Planning Commission Meeting

May 9, 2023 6:00 PM

4.I. 3034, 3038, and 3044 Springdale Road Site Plan Review

DATE: May 2, 2023
 TO: Adrienne Senter
 FROM: Lynn Patterson
 RE: **Site Plan Review – 3034 to 3044 Springdale Road Townhomes, Revised**

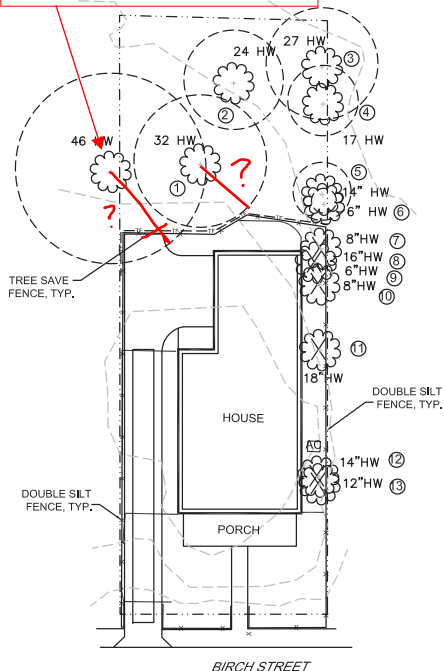
Please read the definition of boundary tree in the Ordinance and provide documentation that letter has been sent

Verify with planning dept. that no street trees are required.
